CHAPTER 6 DESIGN REVIEW OF CHENNAI PERIPHERAL RING ROAD (CPRR)

6.1.1 Objectives and Scope of Design Review of CPRR

In order to confirm the reasonability of providing the Japan International Coordination Agency (JICA) Loan to the CPRR Project, the review is undertaken on the design made in the Detailed Project Report (DPR).

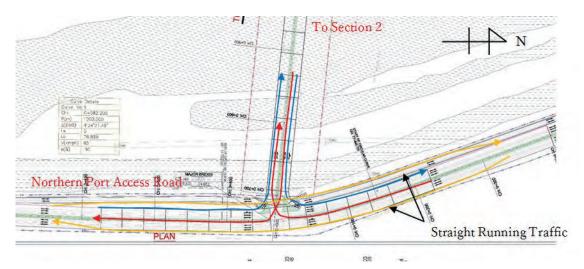
Vehicles going straight (south to north) are assigned to the ground level in order to increase the capacity of the intersection, and left turn (south to west and west to north) and right turn (west to south and north to west) are allowed at the intersection. Therefore, the signal becomes two phases. The improvement plan is shown in Figure 6.2.5.

Figure 6.3.4 Plan of IC-1

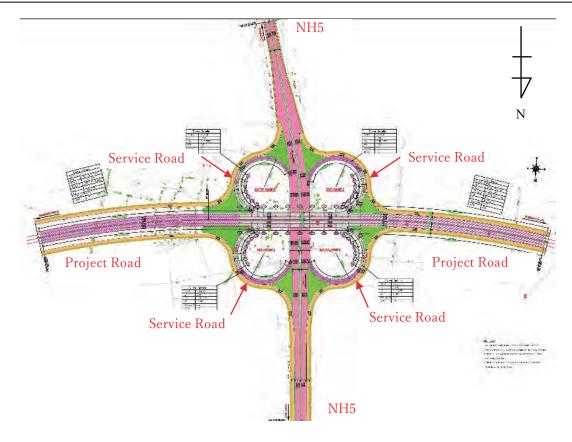
It is desirable to insert the transition curve between the straight line and curve (R=70 m, e=5%).

Recommended Plan for IC-1

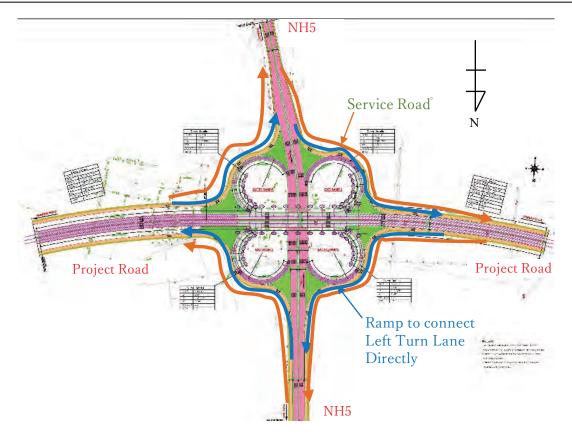
The abovementioned improvement proposal is shown in Figure 6.3.5.

Figure 6.3.8 Proposal of the Abovementioned Improvement

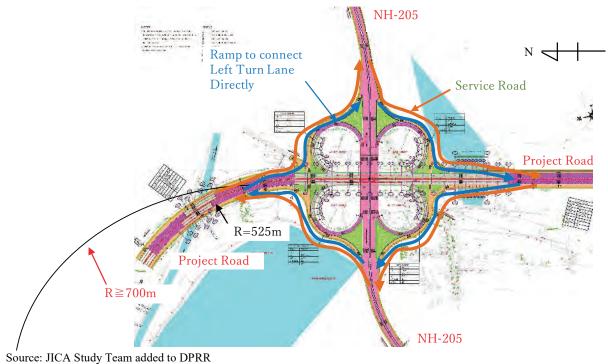
To improve safety, it is recommended to apply a radius bigger than 700 m, which is prescribed in the standards of the Road Structure Ordinance of Japan for curve radius of ramp terminal of main road with design speed of 80 km/h.

Figure 6.3.11 Recommended Plan for IC-3

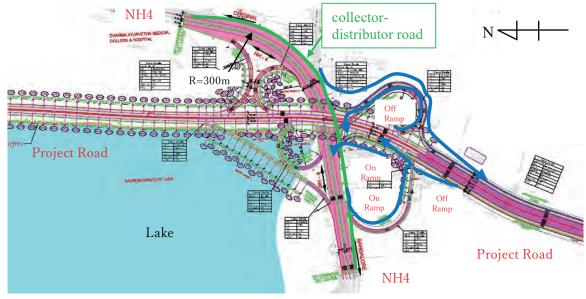
It is recommended to install the acceleration lane (parallel type) and deceleration lane (direct taper type) according to the standard of ramp terminal (IRC: 92-1985).

Figure 6.3.14 Recommended plan for IC-4

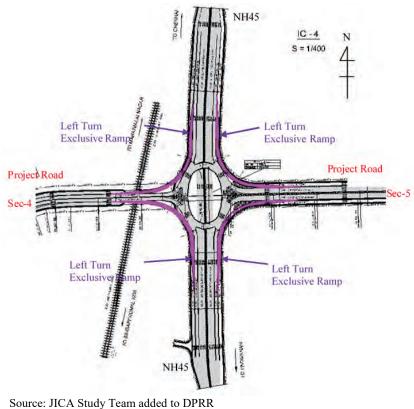
It is recommended to add a separate left-turn rampway outside the roundabout in order to increase the capacity of the roundabout.

Figure 6.3.14 shows the recommended plan for IC-4.

Figure 6.4.3 Draft Railroad Plan at MJB101 Start Point

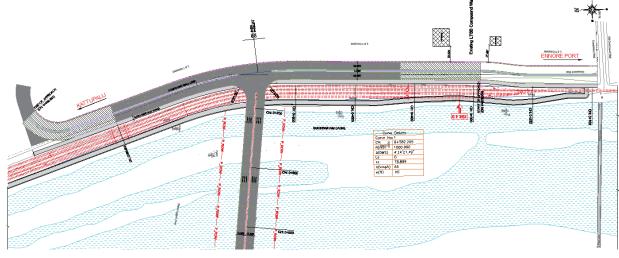
Details of the MJB101 railroad plan such as clearances, determination of bridge type based on construction limits, and span arrangement must be reflected in the detailed design. The railway company must be involved in the confirmation process as well.

Figure 6.4.7 MJB501 : Type of Substructure Located at Bridge Ends (Abutment)

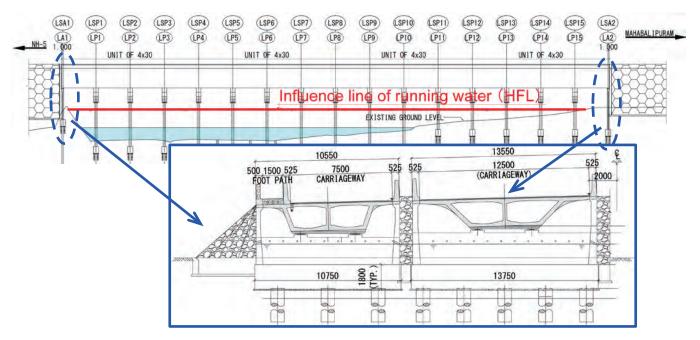
Sec.	No.	STRUCTURE	Location		Revision Suggestion		
Sec.	INO.	CODE	Location	Plan of DPR	Affected by running water		Suggestion
			A1(Start point)	Pier + RE Wall	No (land)	\rightarrow	No change
Sec.1	1	MJB101-1 Str.No.1/1	A3 End point	Pier + RE Wall	Yes	\rightarrow	<u>Change from pier to</u> <u>Abutment</u>
		MJB101-2 Str.No.1/1	A2(End point)	Pier + RE Wall	No (land)	\rightarrow	No change
			A1(Start point)	Pier + RE Wall	No (land)	\rightarrow	No change
Sec.2	2	MJB202 Str.No.30/3	A2(End point) Pier + RE Wall Yes		Yes	\rightarrow	<u>Change from pier to</u> <u>Abutment</u>
	3	MJB201 Str.No.37/4	A1(Start point)	Abutment	Yes	\rightarrow	No change
	3	MJB201 Str.N0.37/4	A2(End point)	Abutment	Yes	\rightarrow	No change
		MJB301 Str.No.58/3-1 (Main Road)	A1(Start point)	Pier + RE Wall	Yes	\rightarrow	<u>Change from pier to</u> <u>Abutment</u>
Sec.3	4	()	A2(End point)	Pier + RE Wall	No (land)	\rightarrow	No change

Source: DPR Plan&Profile(14518/E/PP/DD209), Drawing(14518/E/MJB202/DD001: SH-1 OF 3) Figure 6.4.10 Mistake in Plan & Profile

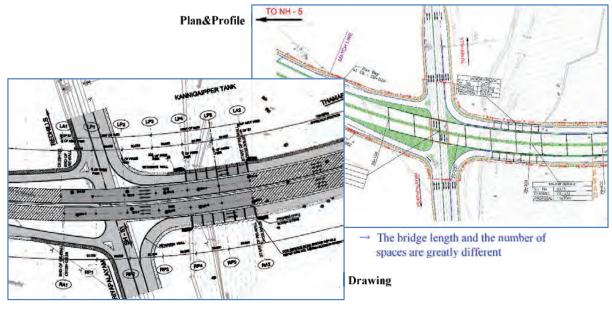
There is a lot of difference in the Plan &Profile and the Drawing of the structure of MJB202 (Str. 30/3). Based on the topography, the content of the Drawing is correct. It is considered that there is a mistake in the updated Plan & Profile. Therefore, a correction is being suggested.

Source: JICA Study Team based on DPR (Drawing: MNB101) Figure 6.4.12 Bridge Cross Section (MNB101)

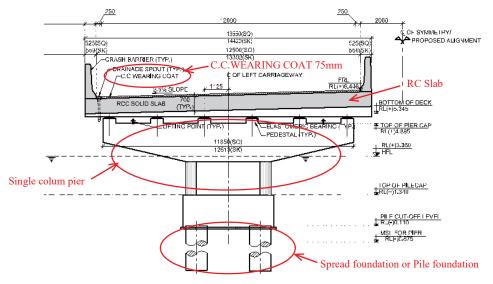
In the final DPR, the planned bridge pavement material is concrete. However, asphalt pavement is used in the vicinity of the earthworks section as well as ORR, while concrete asphalt is used in the already constructed bridge at the end of Section 4. Although material procurement could be the main consideration, other factors such as consistency must also be considered in the determination of pavement material during the detailed design.

Figure 6.4.13 Several Piers on the River (MNB501)

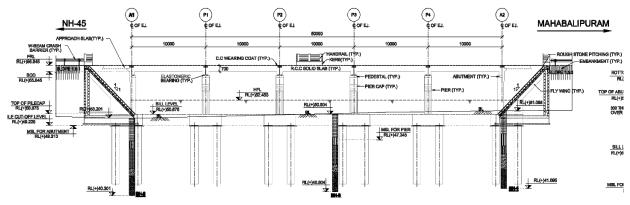
As mentioned above, the span of several MNBs is set at the minimum 10 m. The DPR considers improving the accuracy of the bridge plan including structural investigation at the time of detailed design by setting the short span and economical RC slab bridge as standard. The following should be examined and confirmed at the time of detailed design:

- Investigation to increase economic efficiency by increasing the span and reducing the number of piers.
- Study to improve the river flow and constructability by reducing pier on the river.
- > Confirmation of bridge plan details through consultation with environmental authorities.

Source: DPR Plan&Profile(14518/E/PP/DD209), Drawing (14518/E/MJB202/DD001: SH-1 OF 3) Added by the JICA Study Team Figure 6.4.20 VUP Shown in the Plan&Profile

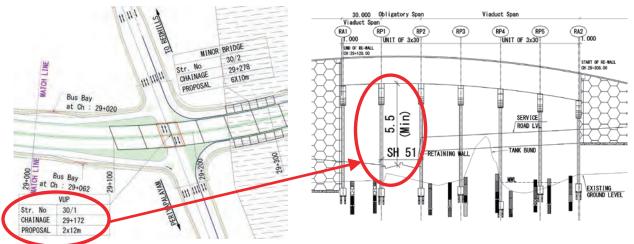
Since MJB is located at the same location as VUP (Str. 30/1) as described in Plan & Profile, the VUP is considered unnecessary. It is proposed to revise the plan upon confirmation.

Source: JICA Study Team based on DPR Plan&Profile(14518/E/PP/DD329) Figure 6.4.21 Location of Road Crossing (Near Section 3 Ch. 70+020)

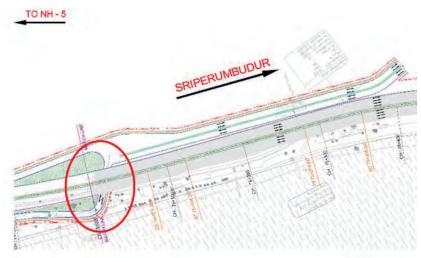
For the road crossing, there is no VUP around Ch. 75+020. Since VUP is considered to be necessary in the said location, it is proposed to add a VUP upon confirmation.

Source: JICA Study Team based on DPR Drawing (14518/E/IC/NH5/DD001: SH-2 OF 3) Figure 6.5.18 Cross Section of Reinforced Earth Wall (IC)

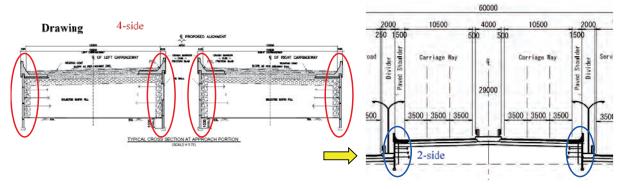
Reinforced earth walls are placed between each gap of the upper and lower lanes of IC. The total number of faces is four. The said gap is about 3 m high if it is filled with soil. There will be two installation faces of reinforced earth wall which in turn will be economical. For bridges other than IC, there are two faces, but this should be reviewed in the detailed design.
